MATRIX		Service Bulletin	
		Matrix 2016 7xi/7xe and T130xi Console Troubleshooting	
Effective Date: Dec. 20, 2016	Models Affected: 7xe-05-C (EP620, TM527); 7xi-03-C (EP621, TM528); T130xi (TM541)	Bulletin Num. NB-1701007 ver.10	
Prepared by: Eric Chen

Table 1: 7xi/7xe Console Troubleshooting List

1.2 - Edition

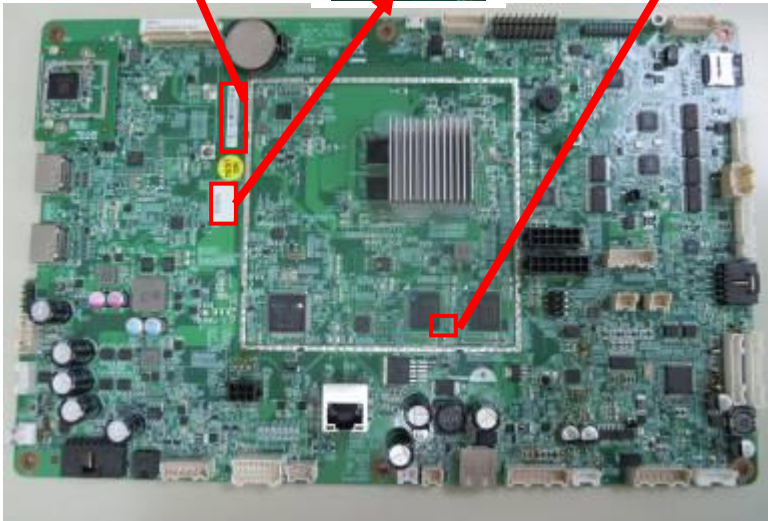
Replace the UCB. JHT has improved the UCB. The design change summary is shown below.

1.1 The starting S/N of new UCB is **TBBG11025063**.

1.2 The starting edition of new UCB is **60JG**.

1.3 The components that were changed are capacitors **C594/C586 (30pf)**.

1.4 The new application starts from **November 2016**.

See the below LCM photo (old/new).

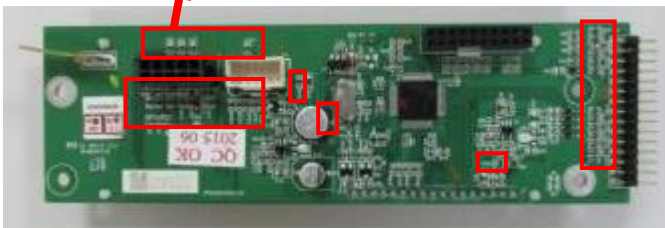
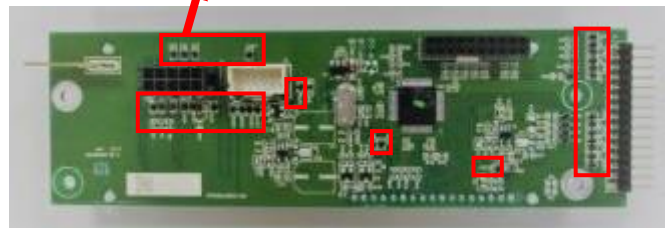
1. Replace the LCM Control Board Set. JHT has improved the LCM Control Board Set.
2. The major change components are TVS diodes VZ1~VZ9, VZ10~VZ29, VZ36 and VZ37.
3. The starting S/N of new LCM Control Board Set is **1738102197**.
4. The new application starts from November, 2017 (plan).

Old TVS diodes- e.g.VZ3/VZ1/VZ7/VZ27

New TVS diodes- e.g. VZ3/VZ1/VZ7/VZ27
